FINAL DRAINAGE PLAN

THE RIDGE AT LORSON RANCH

JANUARY, 2022

Core Engineering Group, LLC
15004 1ST Avenue South
Burnsville, MN 55306
(719) 570-1100

**EXISTING CONDITIONS
 PUD / PRELIMINARY PLAN
 THE RIDGE AT LORSON RANCH**

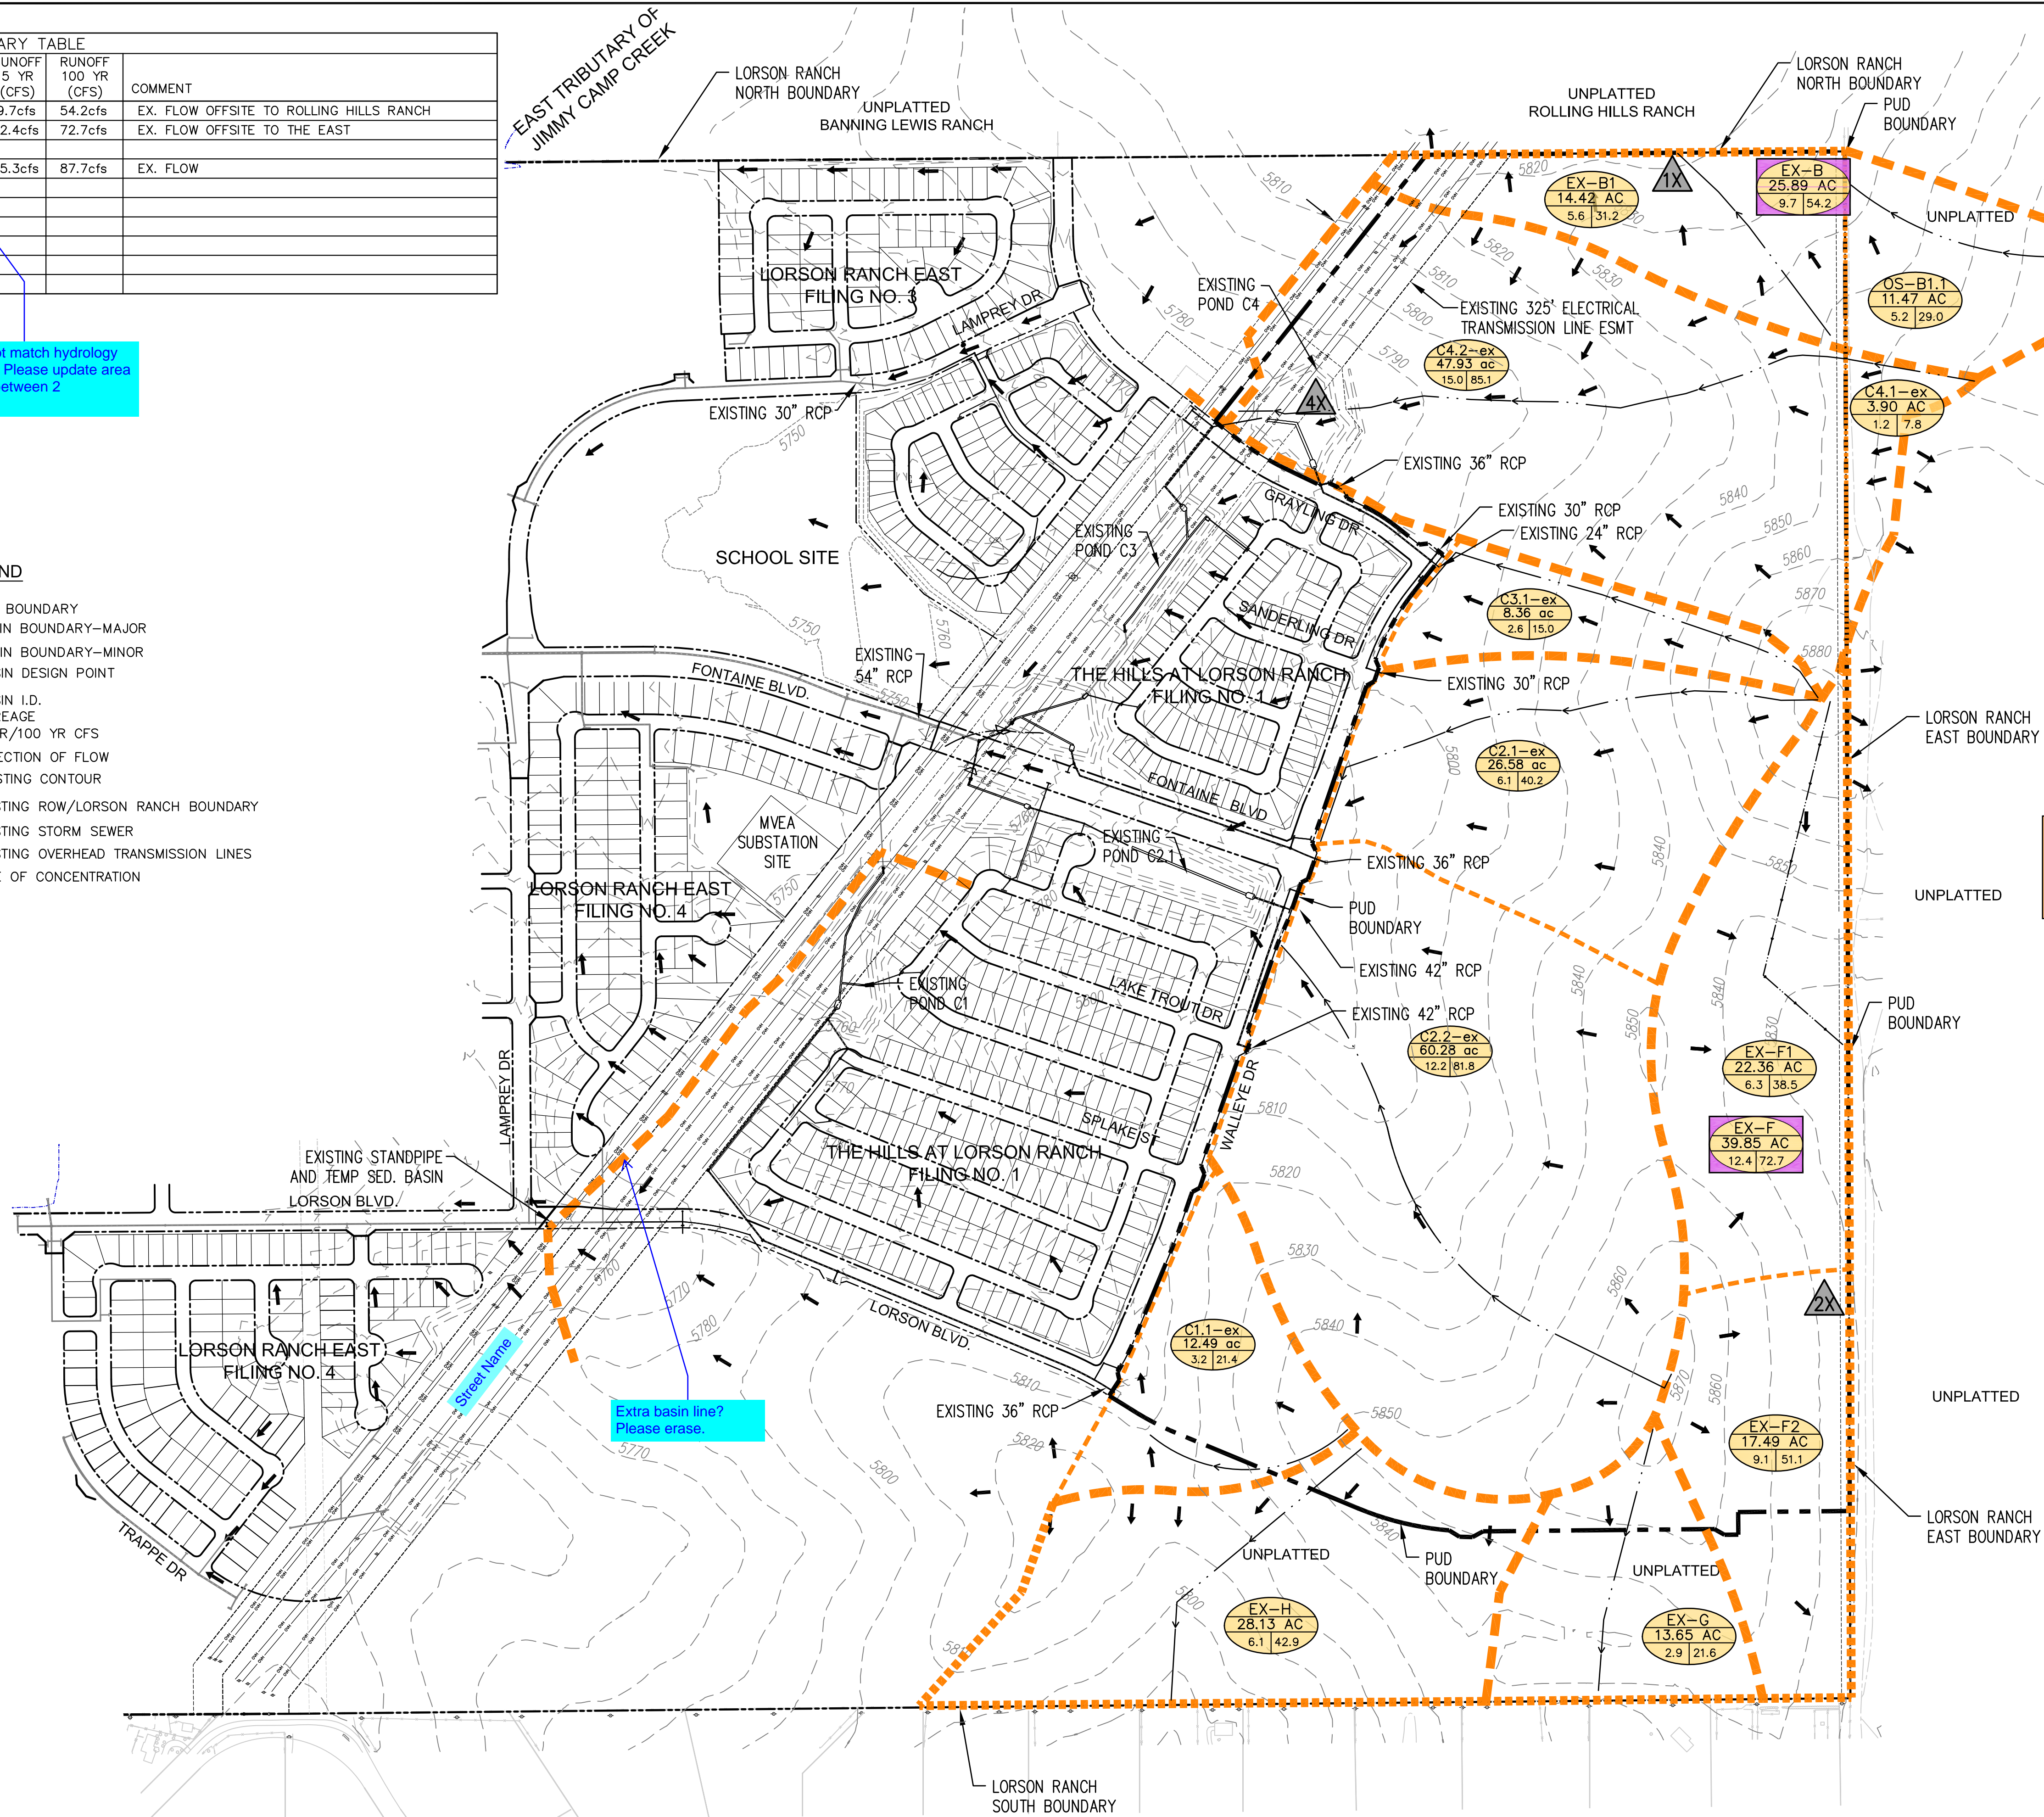
Include basin summary table

Show borders of The Ridge Filings 1, 2, and 3.
Typical comment for all subsequent maps.

Extra basin line?
Please erase.

DEVELOPED CONDITIONS
THE RIDGE AT LORSON RANCH
 X

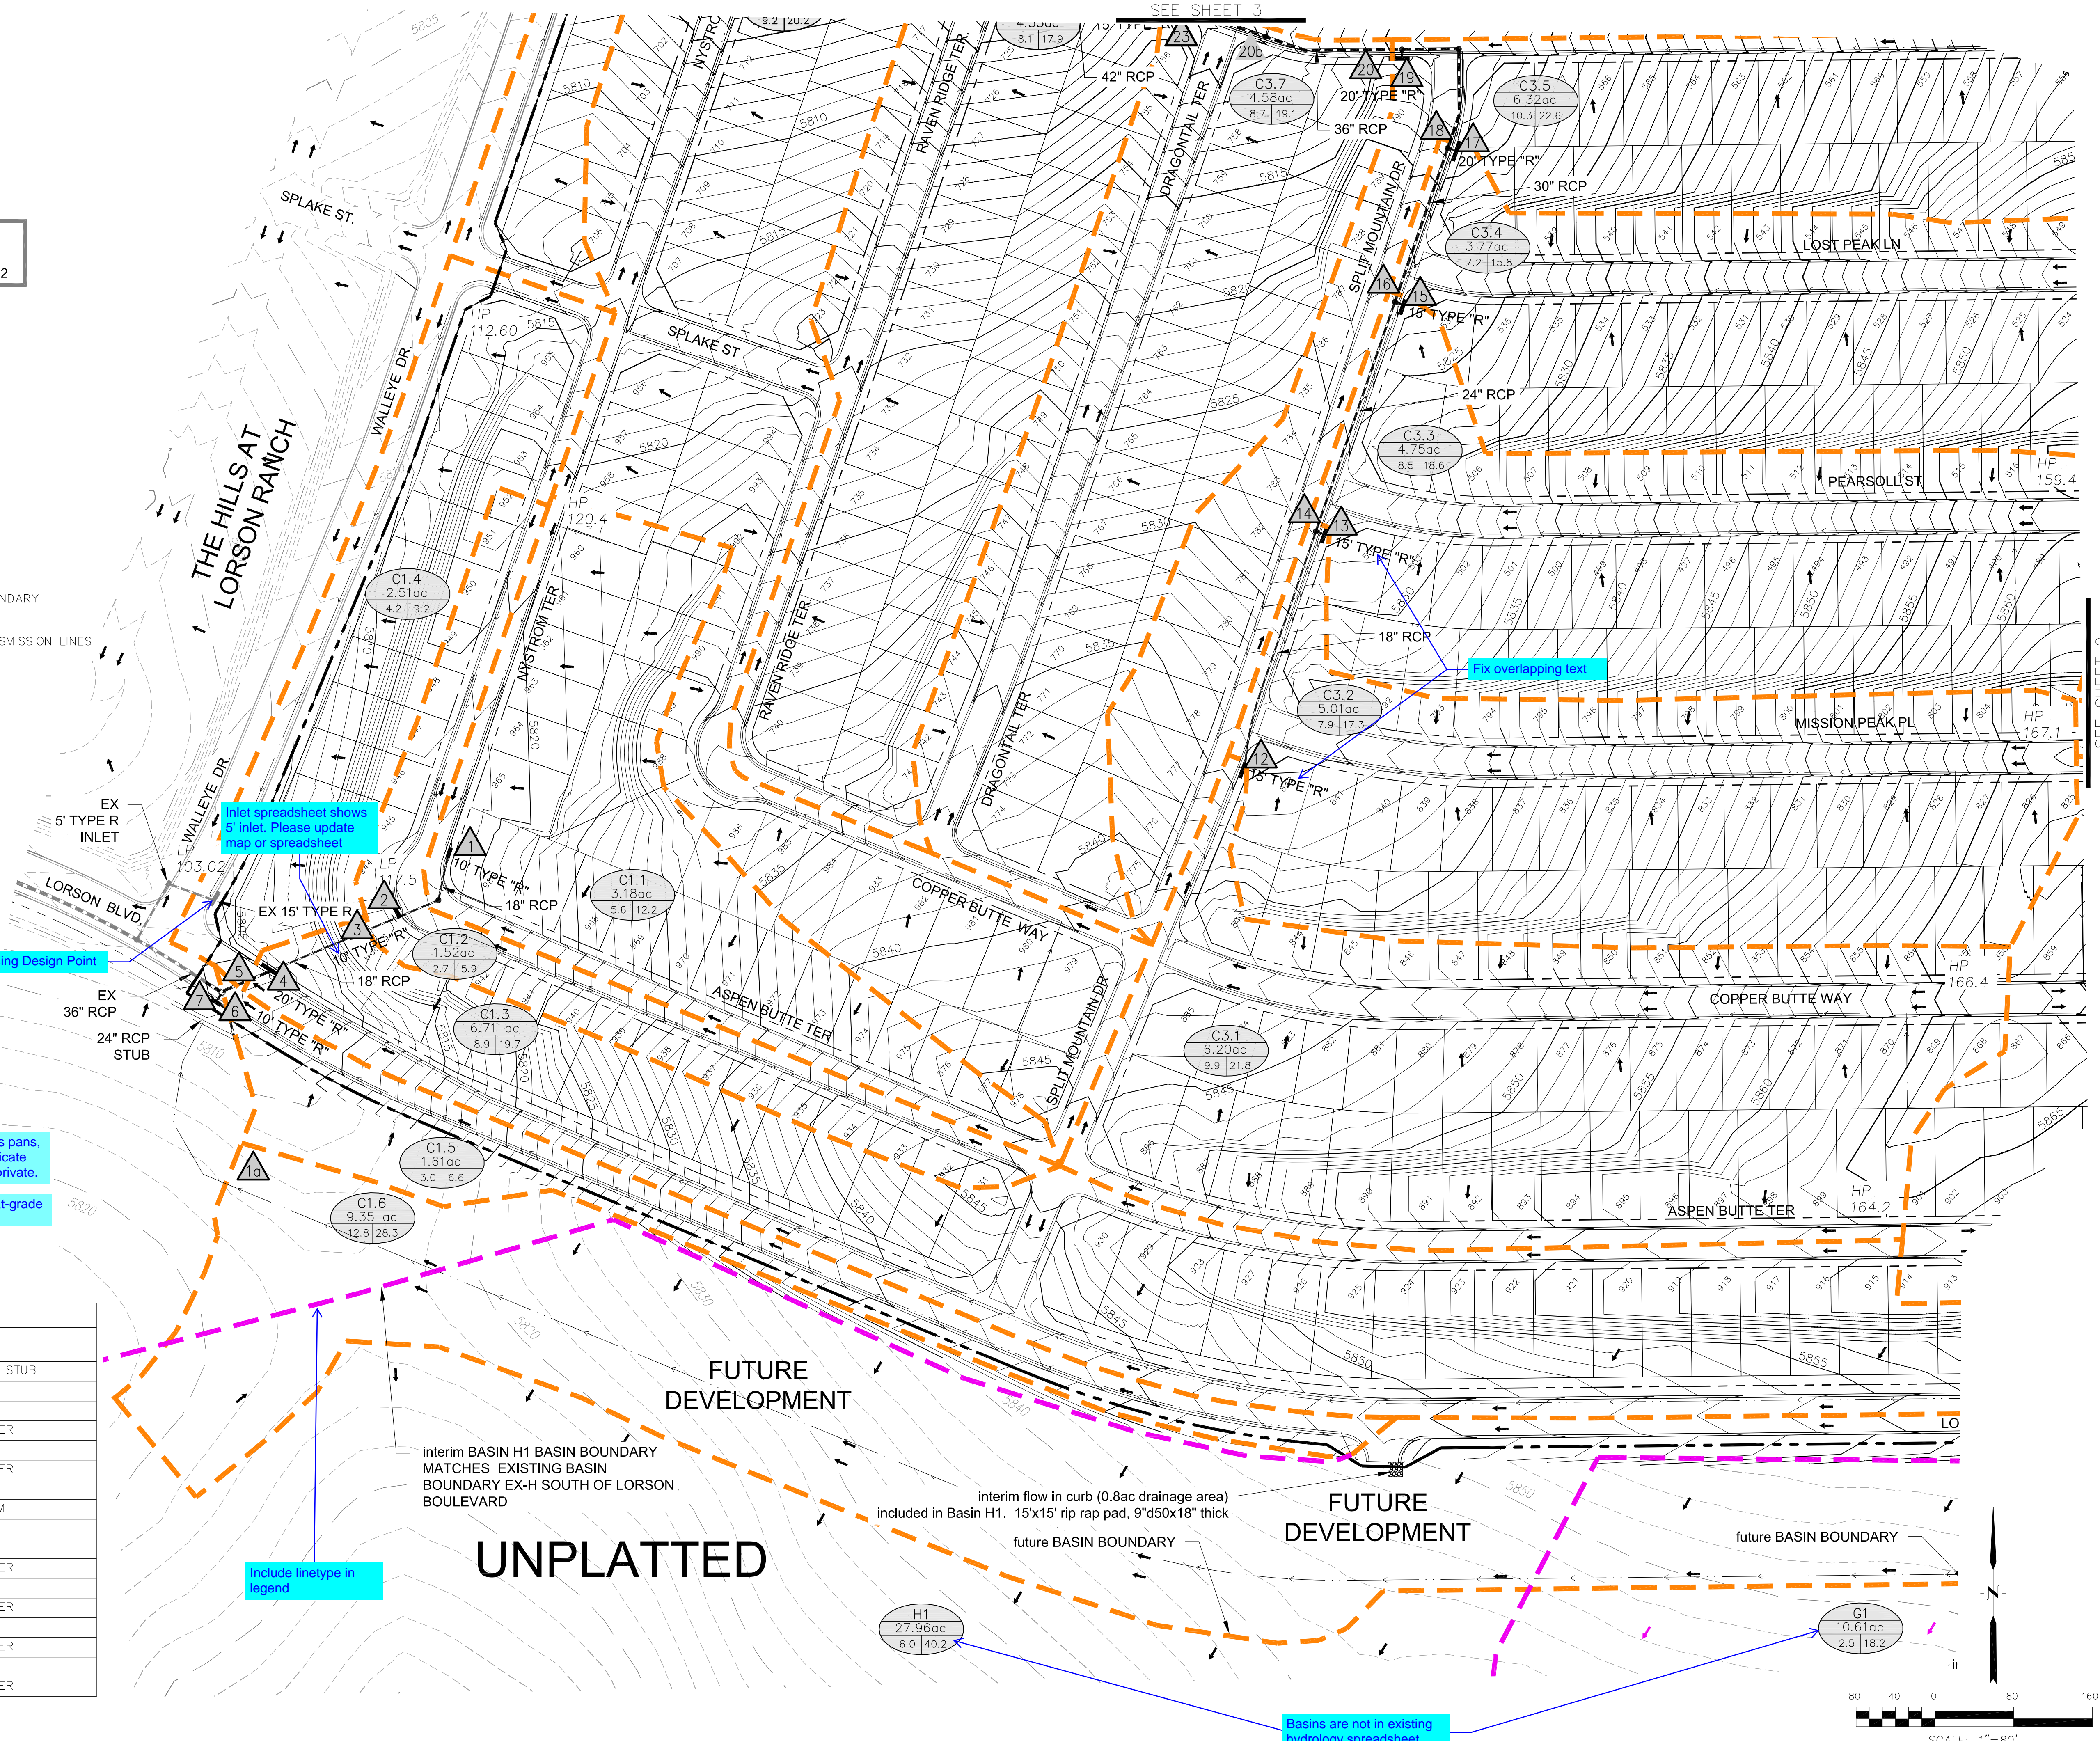
- Include 1 Overall map
- Label all curb types, cross pans, manholes, pipes, etc. Indicate what items are public or private.
- Label inlets as sump or at-grade
- Update design point summary table. Missing design points between hydrology spreadsheet & table and flows are not matching spreadsheet (all sheets)

Include linetype in legend

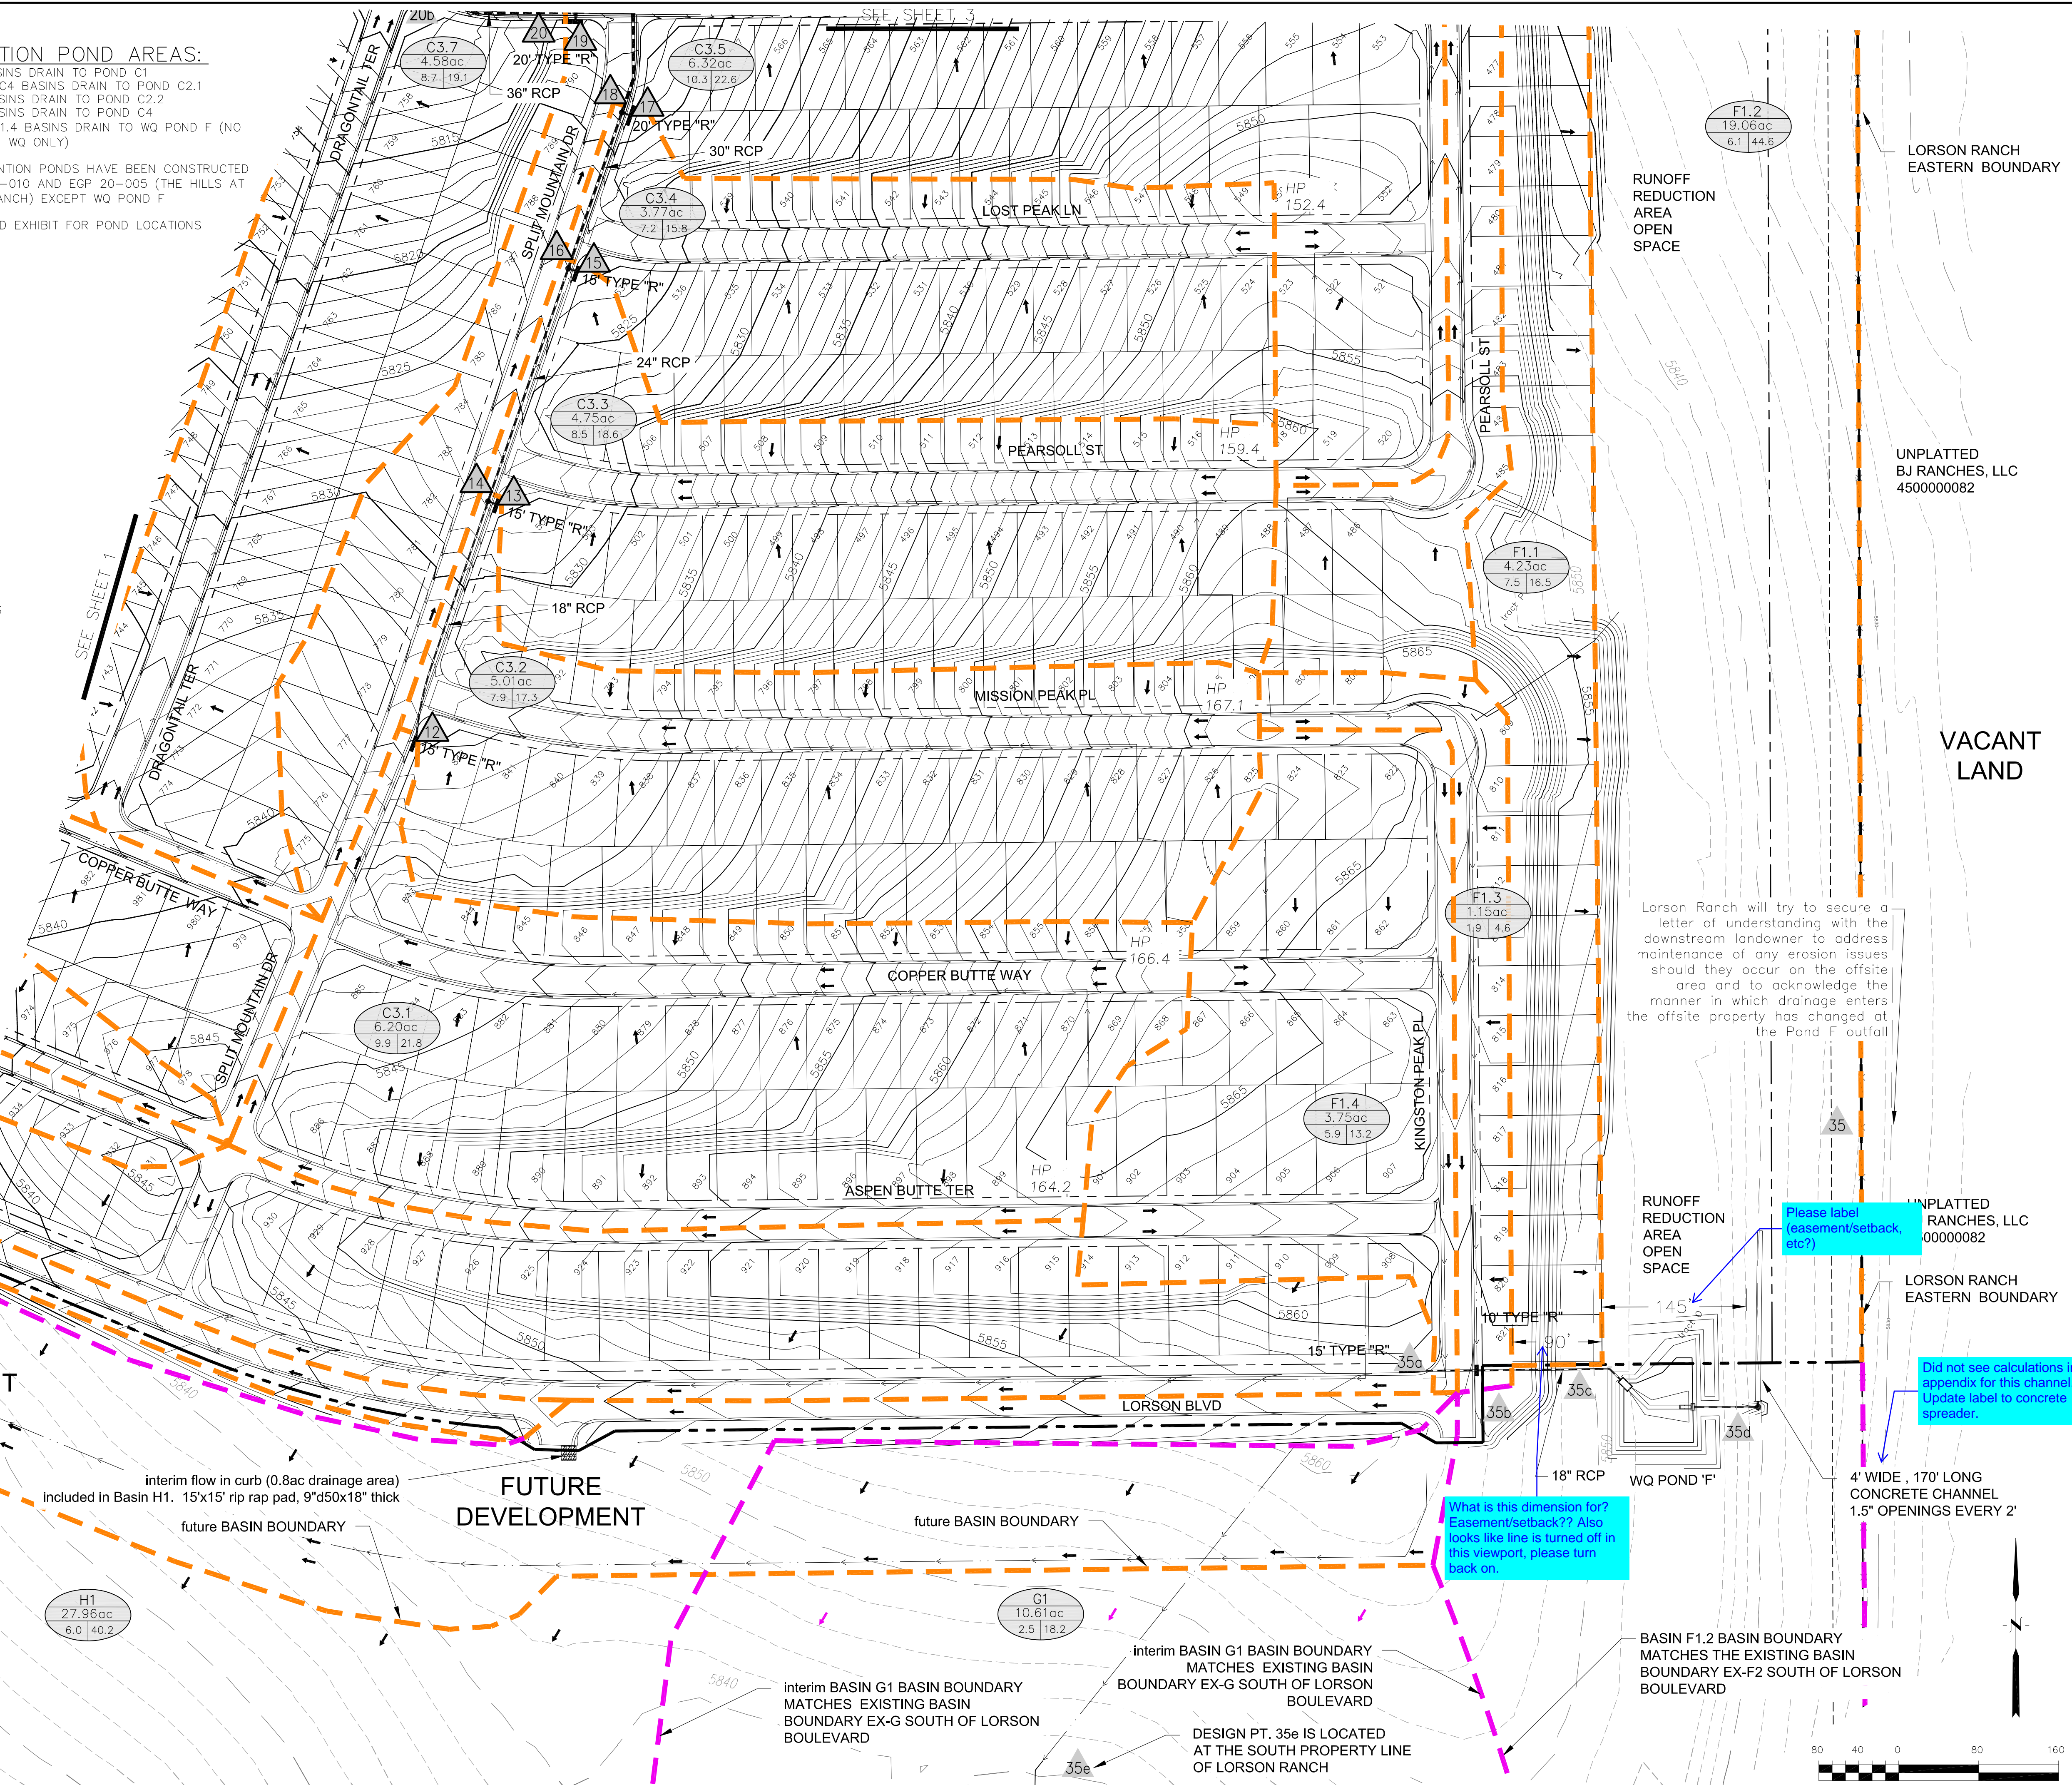
Please label (easement/setback, etc?)
